NEEDS ASSESSMENT AND LEVEL OF SERVICE EVALUATION

APPENDIX D: AMERICANS WITH DISABILITIES ACT (ADA) FACILITY BARRIER REPORT

Americans with Disabilities Act (ADA) Facility Barrier Report

For Selected Park Sites

Bella Vista Park

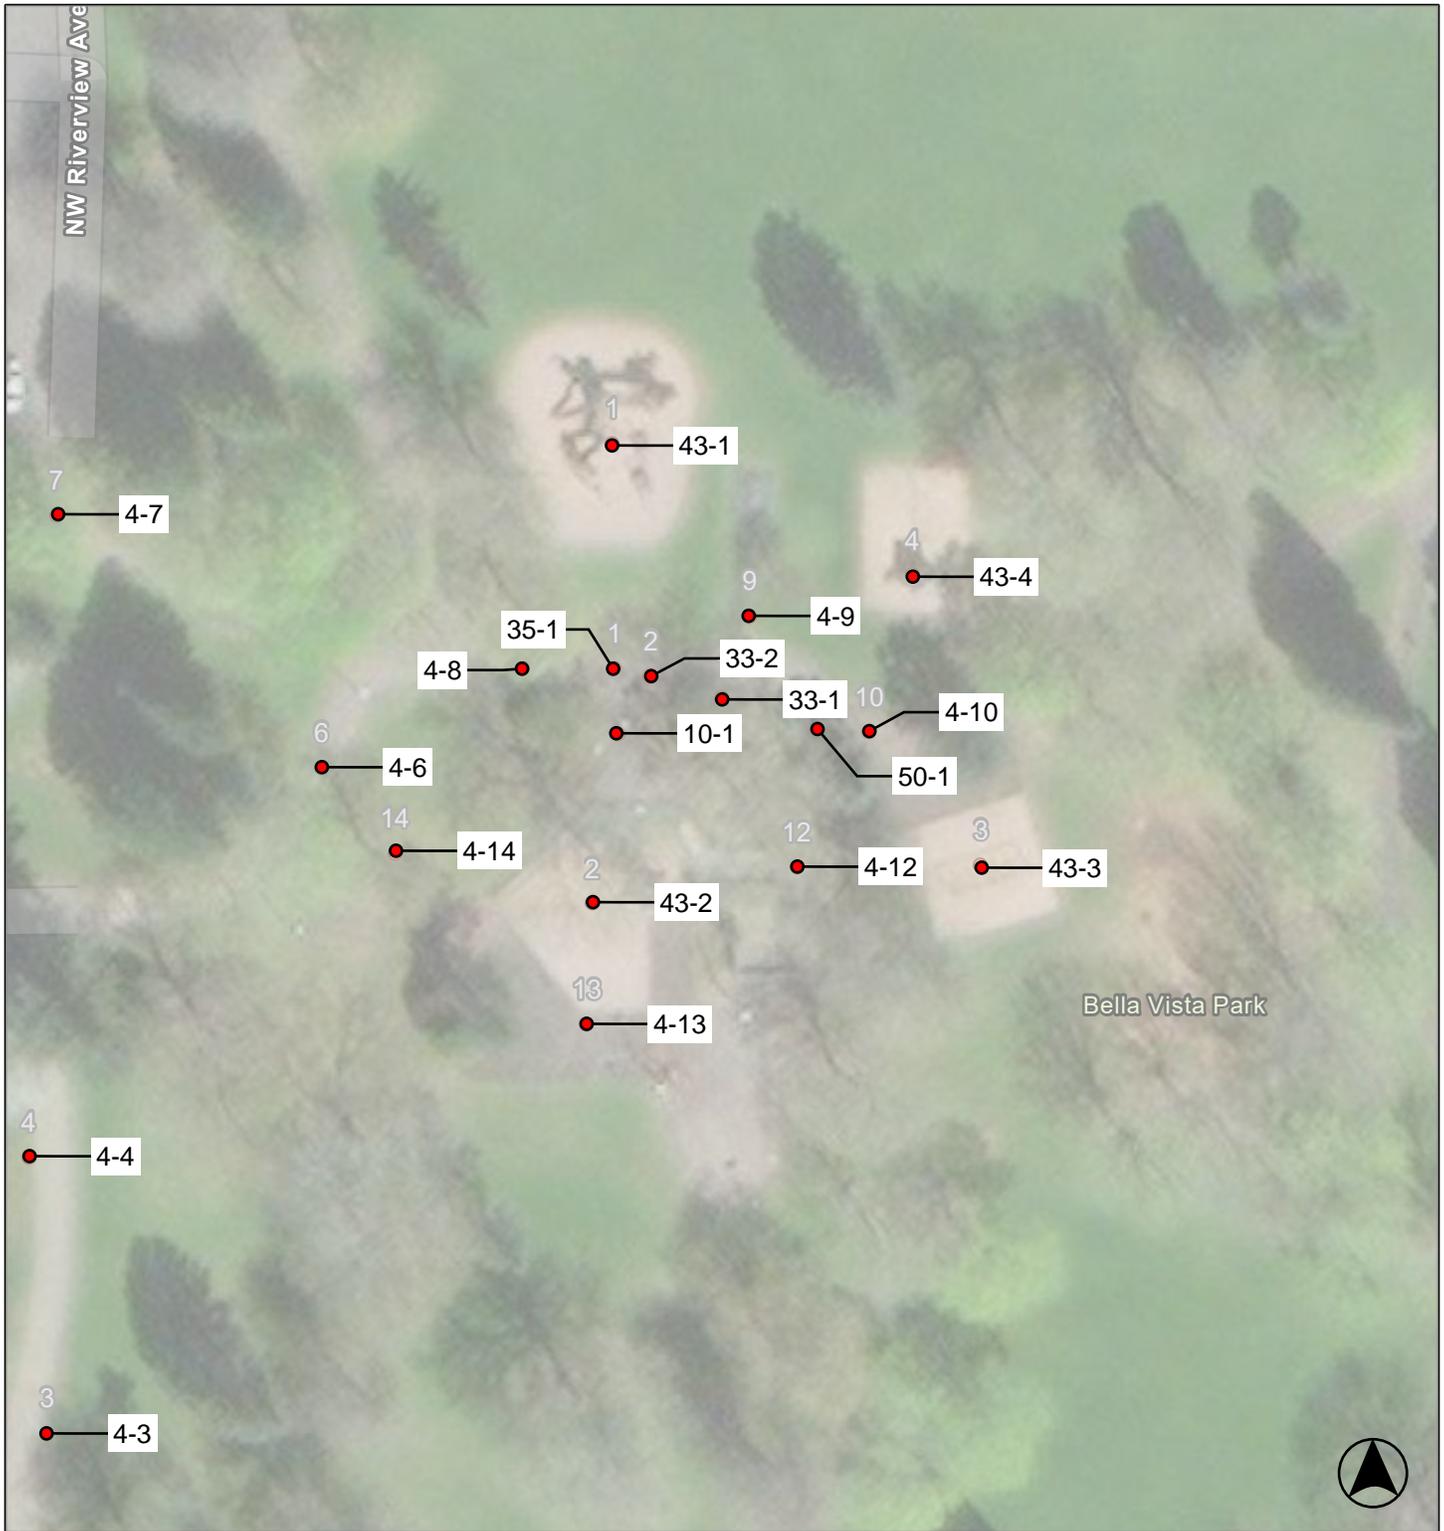
Park	
4 - 12	Walk Category: 1
Regrade surface	\$4,700
Notes: Running slope of ramp near play area is up to 23.9% for 47 linear feet (5.0% max).	
ADA: 403.3	
Other: -	
Grind or patch vertical change of grade	\$100
Notes: Surface level change is greater than 1/2" due to crack (1/4" max; up to 1/2" with a 1:2 bevel).	
ADA: 303.2, 303.3	
Other: -	
4 - 13	Walk Category: 1
Regrade surface	\$8,400
Notes: Cross slope of concrete around play area is up to 5.6% for 84 linear feet (2.0% max).	
ADA: 403.3	
Other: -	
Reduce or eliminate opening	\$300
Notes: Gap at crack in concrete is greater than 1/2" (1/2" max).	
ADA: 302.3	
Other: -	
4 - 14	Walk Category: 1
Regrade surface	\$2,000
Notes: Cross slope of concrete is up to 6.0% for 20 linear feet (2.0% max).	
ADA: 403.3	
Other: -	
4 - 15	Walk Category: 1
Regrade surface	\$6,600
Notes: Cross slope of concrete is up to 3.9%, run slope is up to 11.1% for 66 linear feet (2.0% max).

Park	
10 - 1 Drinking Fountain	Category: 3
Increase or provide maneuvering or clear floor area	\$1,270
Notes: There is a 2" vertical change in level at the clear floor space of the fountain (1/2" max).	
The clear floor space in front of the fountain is 17" wide (30" min).	
ADA: 305.1, 305.2, 305.3, 305.5, 306.1	
Other: -	
Confirm water flow compliance	\$0
Notes: Water service to the drinking fountain was disconnected at the time of the assessment. Flow height and angle could not be confirmed.	
ADA: 602.3, 602.6	
Other: -	
33 - 1 Outdoor Constructed Features	Category: 3
Increase or provide clear floor area	\$200
Notes: A clear ground space is not provided adjacent to the bench (36" by 48" min).	
ADA: -	
Other: ABA 1011.2.1, ABA 1011.2.3	
33 - 2 Outdoor Constructed Features	Category: 3
Regrade surface	\$20
Notes: Clear ground space adjacent to the trash container has a slope of 7.5% (2.0% max).	
ADA: 305.1	
Other: ABA 1011.2.3

33 - 3 Outdoor Constructed Features	Category: 3
Increase or provide clear floor area	\$200
Notes: A clear ground space is not provided adjacent to the bench (36" by 48" min).	
ADA: -	
Other: ABA 1011.2.1, ABA 1011.2.3	
33 - 4 Outdoor Constructed Features	Category: 3
Increase or provide clear floor area	\$200
Notes: A clear ground space is not provided adjacent to the bench (36" by 48" min).	
ADA: -	
Other: ABA 1011.2.1, ABA 1011.2.3	
33 - 5 Outdoor Constructed Features	Category: 3
Increase or provide clear floor area	\$200
Notes: A clear ground space is not provided adjacent to the bench (36" by 48" min).	
ADA: -	
Other: ABA 1011.2.1, ABA 1011.2.3

Park	
33 - 6	Outdoor Constructed Features Category: 3
Increase or provide clear floor area	\$200
Notes: A clear ground space is not provided adjacent to the bench (36" by 48" min).	
ADA: -	
Other: ABA 1011.2.1, ABA 1011.2.3	
35 - 1	Other Category: 3
Reposition controls	\$285
Notes: Operating mechanism of dog bag station is 60" above the ground (15" min to 48" max).	
ADA: 308.2, 308.2.1	
Other: -	
43 - 1	Play Equipment Area Category: 2
Improve or evaluate play area surface	\$0
Notes: Ground surface in play area is in need of maintenance and further evaluation of fall attenuation surface is recommended.	
ADA: 1008.2.6.1, 1008.2.6.2	
Other: -	
43 - 2	Play Equipment Area Category: 2
Improve or evaluate play area surface	\$0
Notes: Ground surface in play area is in need of maintenance and further evaluation of fall attenuation surface is recommended.	
No accesible route to the slide landing.	
ADA: 1008.2.6.1, 1008.2.6.2

Other: -	
43 - 3	Play Equipment Area Category: 2
Improve or evaluate play area surface	\$0
Notes: Ground surface in play area is in need of maintenance and further evaluation of fall attenuation surface is recommended.	
ADA: 1008.2.6.1, 1008.2.6.2	
Other: -	
Regrade or replace ramp	\$540
Notes: The ramp into the play area has a 10.3% slope (8.33% max).	
ADA: 240.2.1	
Other: -

Park	
43 - 4	Play Equipment Area Category: 2
Improve or evaluate play area surface	\$0
Notes: Not surveyed due to closure.	
ADA: 1008.2.6.1, 1008.2.6.2	
Other: -	
47 - 1	Trails Category: 2
Install sign	\$250
Notes: A trail sign is not provided.	
ADA: -	
Other: ABA 1017.10	
Provide resting interval in path of travel	\$2,540
Notes: A resting interval is required at 30 feet.	
ADA: -	
Other: ABA 1017.4	
Regrade surface	\$4,200
Notes: Trail slope is between 8.3 - 10% for 70 feet (2% max. for concrete, asphalt or boards or 5% max. for all other surfaces).	
ADA: -	
Other: ABA 1017.7.2	
47 - 2	Trails Category: 2
Regrade surface	\$2,400
Notes: Running slope of trail is up to 13% for 40 linear feet (10 feet max when running slope between 10% and 12.5%).	
ADA: -	
Other: ABA 1017.7.1	
47 - 3	Trails Category: 2
Regrade surface	\$4,140
Notes: Up to 5% cross slope for 69 feet (2% max. for concrete, asphalt or boards or 5% max. for other surfaces).

Nadaka Nature Park

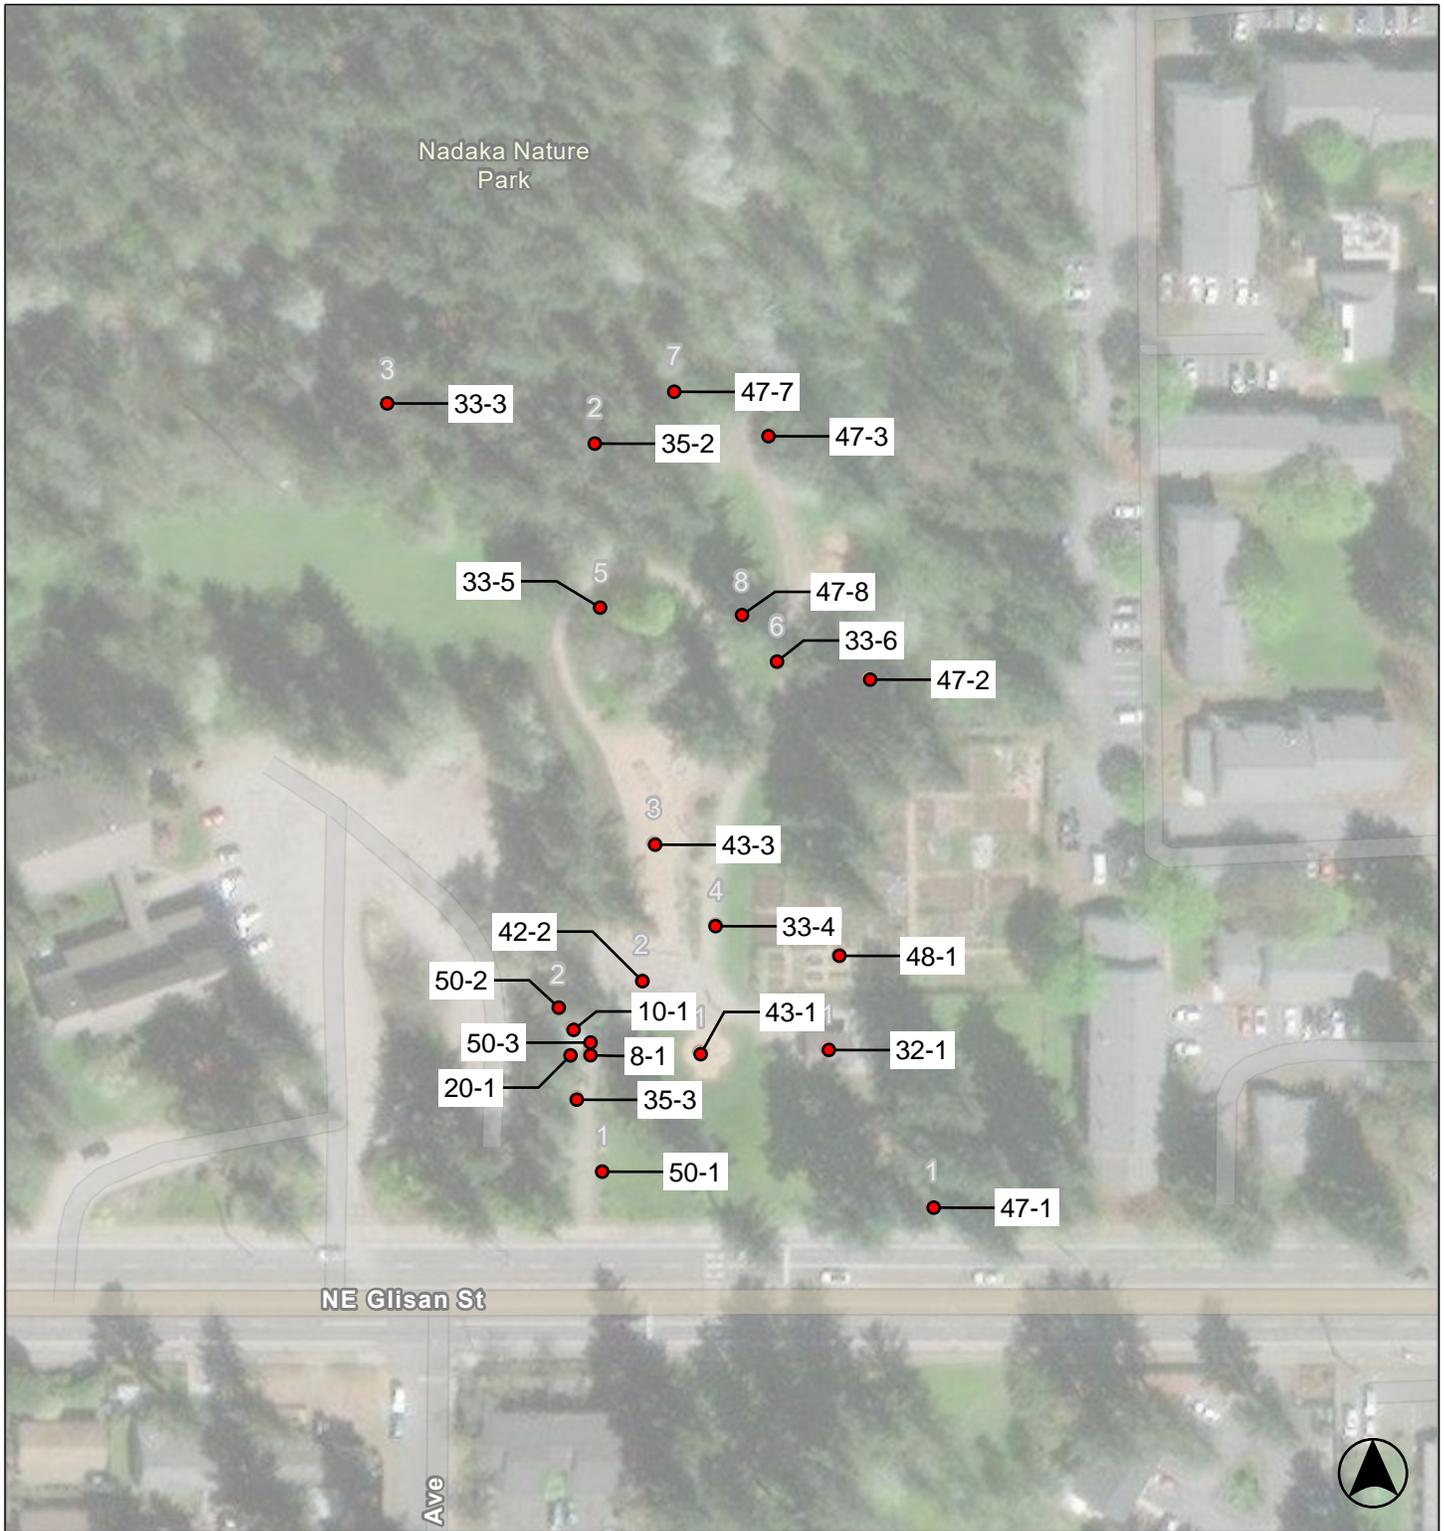
ADA: -	
Other: ABA F245.2.2	
33 - 1	Outdoor Constructed Features Category: 3
Increase or provide clear floor area	\$200
Notes: A clear ground space is not provided adjacent to the bench (36" by 48" min).	
ADA: -	
Other: ABA 1011.2.1, ABA 1011.2.3

Park	
33 - 2	Outdoor Constructed Features Category: 3
Increase or provide clear floor area	\$200
Notes: A clear floor space is not provided at the trash container opening (36" by 48" min forward approach).	
ADA: -	
Other: ABA 1011.2	
Provide an accessible route	\$2,560
Notes: An accessible route to the fixed trash/recycling container is not provided. Route is 32 linear feet over grass from to the container. (48" wide minimum path of travel constructed with an accessible surface)	
ADA: -	
Other: ABA F206.2.2	
33 - 3	Outdoor Constructed Features Category: 3
Increase or provide clear floor area	\$200
Notes: A clear ground space is not provided adjacent to the bench (36" by 48" min).	
ADA: -	
Other: ABA 1011.2.1, ABA 1011.2.3	
Provide an accessible route	\$1,600
Notes: An accessible route to the fixed bench is not provided. Route is 20 linear feet over dirt and grass from route to bench.	
ADA: -	
Other: ABA F206.2.2

33 - 4	Outdoor Constructed Features Category: 3
Increase or provide clear floor area	\$400
Notes: A clear ground space is not provided adjacent to the bench (36" by 48" min). (x2)	
ADA: -	
Other: ABA 1011.2.1, ABA 1011.2.3	
33 - 5	Outdoor Constructed Features Category: 3
Provide an accessible route	\$2,000
Notes: An accessible route to the fixed bench is not provided. Route is 25 linear feet over grass to the bench.	
ADA: -	
Other: ABA F206.2.2

Park	
33 - 6	Outdoor Constructed Features Category: 3
Increase or provide clear floor area	\$200
Notes: A clear floor space is not provided at the trash container opening (36" by 48" min forward approach). Surface is not stable or firm.	
ADA: -	
Other: ABA 1011.2	
35 - 1	Other Category: 3
Increase or provide maneuvering or clear floor area	\$200
Notes: Clear floor space of the dog bag station is not provided (30" by 48" min).	
ADA: 305.2, 305.3, 305.5	
Other: -	
35 - 2	Other Category: 3
Increase or provide maneuvering or clear floor area	\$200
Notes: Clear floor space of the dog bag station is not provided (30" by 48" min).	
ADA: 305.2, 305.3, 305.5	
Other: -	
Provide an accessible route	\$1,200
Notes: An accessible path of travel is not provided to the dog bag station. Surface is grass and dirt for 15 linear feet (firm, stable, and slip resistant).	
ADA: 206.2	
Other: -	
35 - 3	Other Category: 3
Reposition controls	\$285

Park	
43 - 3 Play Equipment Area	Category: 3
Improve or evaluate play area surface	\$0
Notes: Ground surface in play area is in need of maintenance and further evaluation of fall attenuation surface is recommended.	
ADA: 1008.2.6.1, 1008.2.6.2	
Other: -	
Provide an accessible route	\$160
Notes: Gaps in ramp to play area are 1" wide (1/2" maximum). X2 gaps	
ADA: 1008.2.5.1	
Other: -	
47 - 1 Trails	Category: 3
Provide a firm, stable and slip resistant surface	\$1,480
Notes: The trail surface is not firm and stable. Trail surface is woodchips, dirt, and debris for 37 linear feet.	
ADA: -	
Other: ABA 1017.2	
47 - 2 Trails	Category: 3
Provide a firm, stable and slip resistant surface	\$6,800
Notes: The trail surface is not firm and stable. Trail surface is woodchips, dirt, and debris for 170 linear feet.	
ADA: -	
Other: ABA 1017.2	
47 - 3 Trails	Category: 3
Provide a firm, stable and slip resistant surface	\$8,400

Notes: The trail surface is not firm and stable. Trail surface is woodchips, dirt, and debris for 210 linear feet.	
ADA: -	
Other: ABA 1017.2	
47 - 4 Trails	Category: 3
Provide a firm, stable and slip resistant surface	\$8,600
Notes: The trail surface is not firm and stable. Trail surface is woodchips, dirt, and debris for 215 linear feet.	
ADA: -	
Other: ABA 1017.2

Park	
47 - 5	Trails Category: 3
Provide a firm, stable and slip resistant surface	\$4,600
Notes: The trail surface is not firm and stable. Trail surface is woodchips, dirt, and debris for 115 linear feet. The run slope at the north park entrance is 11% at the transition to the street.	
ADA: - Other: ABA 1017.2	
47 - 6	Trails Category: 3
Provide a firm, stable and slip resistant surface	\$2,600
Notes: The trail surface is not firm and stable. Trail surface is woodchips, dirt, and debris for 65 linear feet.	
ADA: - Other: ABA 1017.2	
47 - 7	Trails Category: 3
Provide a firm, stable and slip resistant surface	\$5,040
Notes: The trail surface is not firm and stable. Trail surface is woodchips, dirt, and debris for 126 linear feet.	
ADA: - Other: ABA 1017.2	
47 - 8	Trails Category: 3
Provide a firm, stable and slip resistant surface	\$1,760
Notes: The trail surface is not firm and stable. Trail surface is woodchips, dirt, and debris for 44 linear feet.

ADA: - Other: ABA 1017.2	
48 - 1	Equivalent Facilitation Consideration Category: 1
EQUIVALENT FACILITATION CONSIDERATION	\$0
Notes: Provide route through the community garden with a stable and firm surface that is 48" wide and clear. Current surface is woodchips.	
ADA: - Other: -	
50 - 1	Universal Design Recommendations Category: 5
Increase or provide clear space	\$0
Notes: Provide a clear floor space for approach to the informational sign. Consider providing a larger text size, tactile information, and/or audio options for visitors with visual disabilities.	
ADA: - Other: -

North Gresham Park

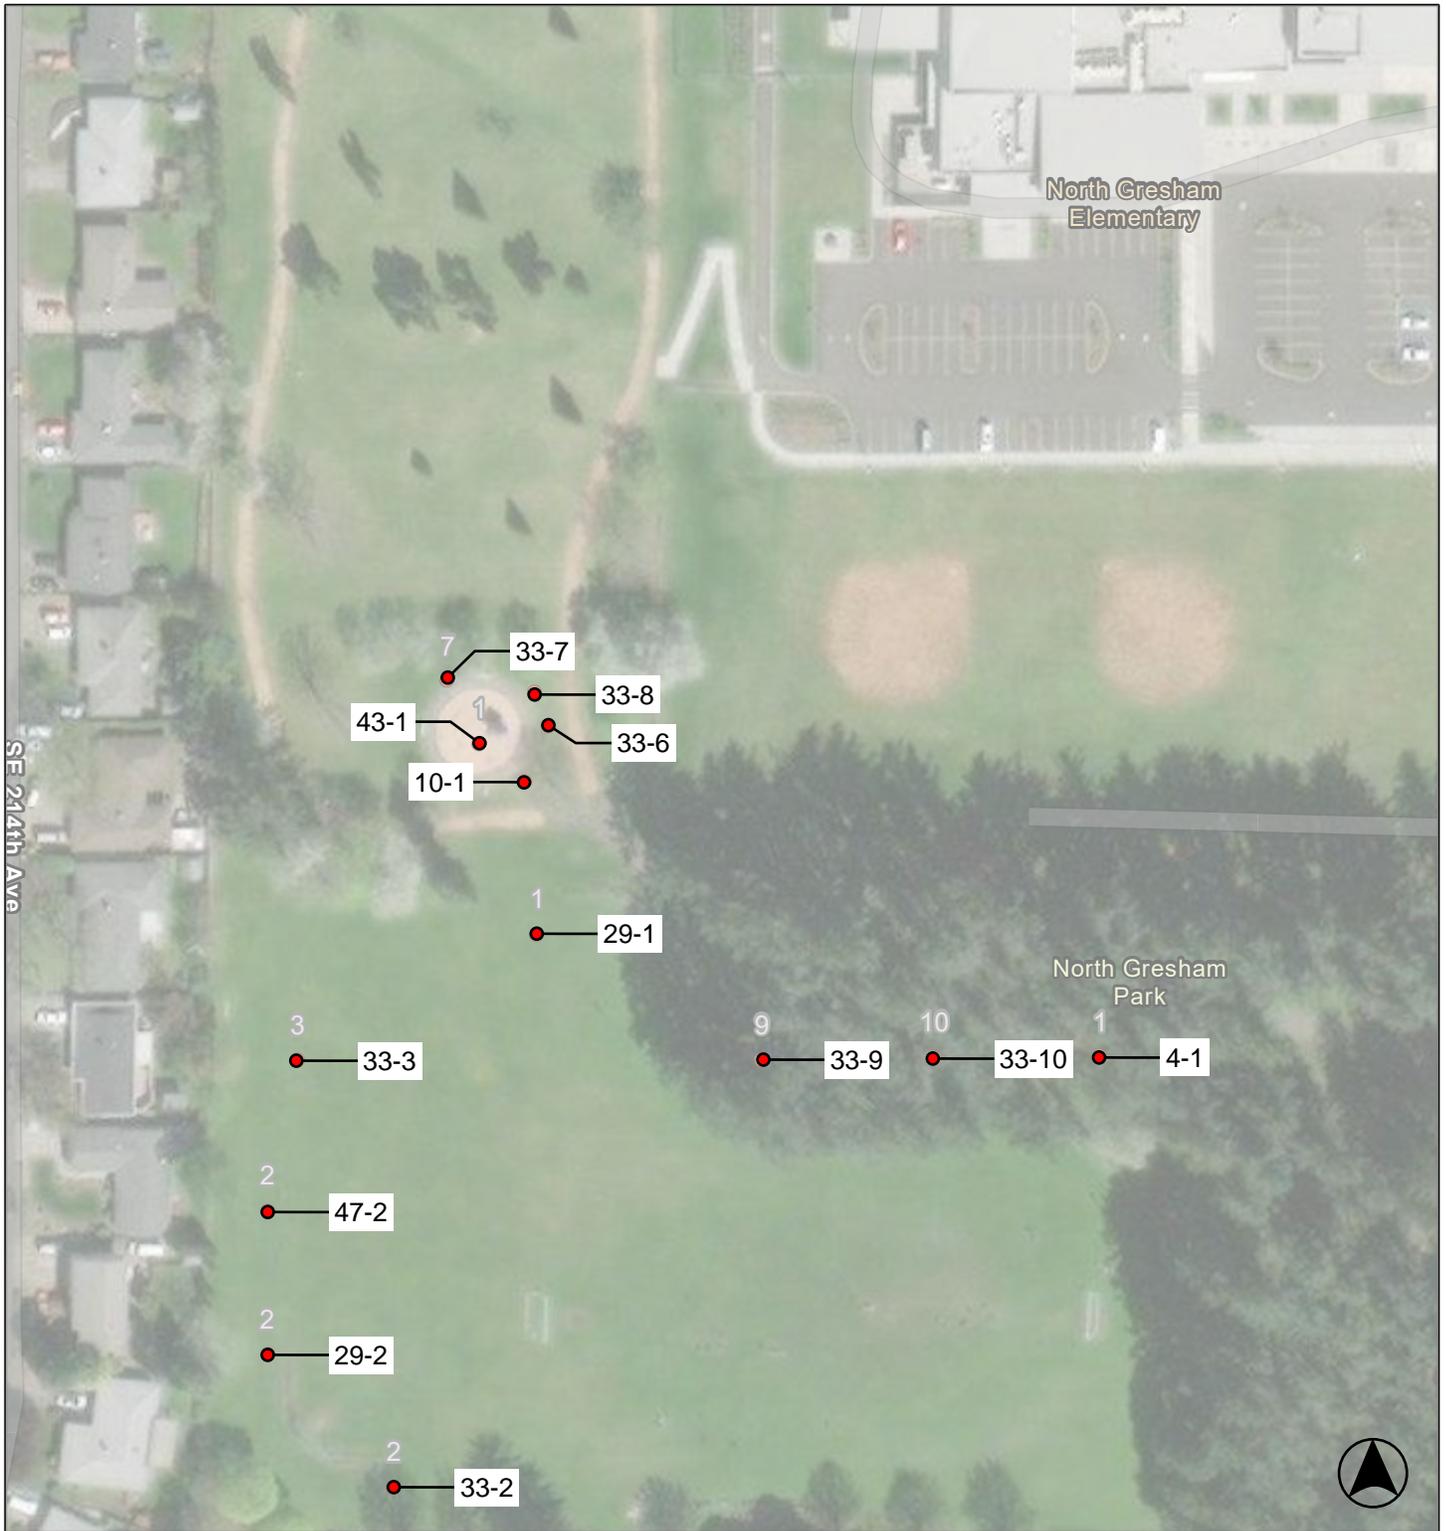
Park		
4 - 1	Walk	Category: 1
Provide an accessible route		\$55,600
Notes: An accessible route is not provided due to grass for 695 linear feet.		
ADA: 206.2.2		
Other: -		
4 - 2	Walk	Category: 1
Provide an accessible route		\$31,440
Notes: An accessible route is not provided from SE Salmon St. to the backstop for 393 linear feet.		
ADA: 206.2.2		
Other: -		
10 - 1	Drinking Fountain	Category: 3
Confirm water flow compliance		\$0
Notes: Water service to the drinking fountain was disconnected at the time of the assessment. Flow height and angle could not be confirmed.		
ADA: 602.3, 602.6		
Other: -		
29 - 1	Game and Sports Area	Category: 2
Provide wheelchair seating		\$3,600
Notes: No wheelchair spaces provided in team seating areas (two min - one per team space).		
ADA: 221.2.1.4		
Other: -		
Provide an accessible route		\$800
Notes: An accessible route to the baseball area is not provided. Route from path to the backstop is 10 linear feet over grass.

ADA: 206.2.2		
Other: -		
29 - 2	Game and Sports Area	Category: 2
Provide wheelchair seating		\$3,600
Notes: No wheelchair spaces provided in team seating areas (two min - one per team space). (x2)		
ADA: 221.2.1.4		
Other: -

Park	
33 - 1	Outdoor Constructed Features Category: 3
Increase or provide clear floor area	\$200
Notes: A clear ground space is not provided adjacent to the bench (36" by 48" min).	
ADA: -	
Other: ABA 1011.2.1, ABA 1011.2.3	
33 - 2	Outdoor Constructed Features Category: 3
Increase or provide clear floor area	\$200
Notes: A clear ground space is not provided adjacent to the bench (36" by 48" min).	
ADA: -	
Other: ABA 1011.2.1, ABA 1011.2.3	
33 - 3	Outdoor Constructed Features Category: 3
Increase or provide clear floor area	\$200
Notes: A clear ground space is not provided adjacent to the bench (36" by 48" min).	
ADA: -	
Other: ABA 1011.2.1, ABA 1011.2.3	
33 - 4	Outdoor Constructed Features Category: 3
Increase or provide clear floor area	\$200
Notes: A clear ground space is not provided adjacent to the bench (36" by 48" min).	
ADA: -	
Other: ABA 1011.2.1, ABA 1011.2.3	
33 - 5	Outdoor Constructed Features Category: 3

Increase or provide clear floor area	\$200
Notes: A clear ground space is not provided adjacent to the bench (36" by 48" min).	
ADA: -	
Other: ABA 1011.2.1, ABA 1011.2.3	
33 - 6	Outdoor Constructed Features Category: 3
Increase or provide clear floor area	\$200
Notes: A clear ground space is not provided adjacent to the bench (36" by 48" min).	
ADA: -	
Other: ABA 1011.2.1, ABA 1011.2.3	
33 - 7	Outdoor Constructed Features Category: 3
Increase or provide clear floor area	\$200
Notes: A clear ground space is not provided adjacent to the bench (36" by 48" min).	
ADA: -	
Other: ABA 1011.2.1, ABA 1011.2.3

Park	
33 - 8	Outdoor Constructed Features Category: 3
Increase or provide clear floor area	\$200
Notes: A clear ground space is not provided adjacent to the bench (36" by 48" min).	
ADA: -	
Other: ABA 1011.2.1, ABA 1011.2.3	
33 - 9	Outdoor Constructed Features Category: 3
Increase or provide clear floor area	\$200
Notes: A clear ground space is not provided adjacent to the bench (36" by 48" min).	
ADA: -	
Other: ABA 1011.2.1, ABA 1011.2.3	
33 - 10	Outdoor Constructed Features Category: 3
Increase or provide clear floor area	\$200
Notes: A clear ground space is not provided adjacent to the bench (36" by 48" min).	
ADA: -	
Other: ABA 1011.2.1, ABA 1011.2.3	
43 - 1	Play Equipment Area Category: 2
Improve or evaluate play area surface	\$0
Notes: Ground surface in play area is in need of maintenance and further evaluation of fall attenuation surface is recommended.	
ADA: 1008.2.6.1, 1008.2.6.2	
Other: -	
Regrade or replace ramp	\$540

Notes: The ramp into the play area has a 10% slope (8.33% max).	
ADA: 240.2.1	
Other: -	
47 - 1	Trails Category: 2
Provide a firm, stable and slip resistant surface	\$80,720
Notes: The trail surface is not firm and stable. Trail surface is loose woodchips for 2018 linear feet.	
ADA: -	
Other: ABA 1017.2	
Install sign	\$250
Notes: A trail sign is not provided.	
ADA: -	
Other: ABA 1017.10

Park	
47 - 2	Trails Category: 2
Provide a firm, stable and slip resistant surface	\$15,520
Notes: The trail surface is not firm and stable. Trail surface is grass and dirt for 388 linear feet.	
ADA: -	
Other: ABA 1017.2	
Install sign	\$250
Notes: A trail sign is not provided.	
ADA: -	
Other: ABA 1017.10	
47 - 3	Trails Category: 2
Provide a firm, stable and slip resistant surface	\$26,880
Notes: The trail surface is not firm and stable. Trail surface is grass and dirt for 672 linear feet. Trail is implied along the South edge of filed with benches, connects to adjacent right-of-way.	
ADA: -	
Other: ABA 1017.2	
Install sign	\$250
Notes: A trail sign is not provided.	
ADA: -	
Other: ABA 1017.10
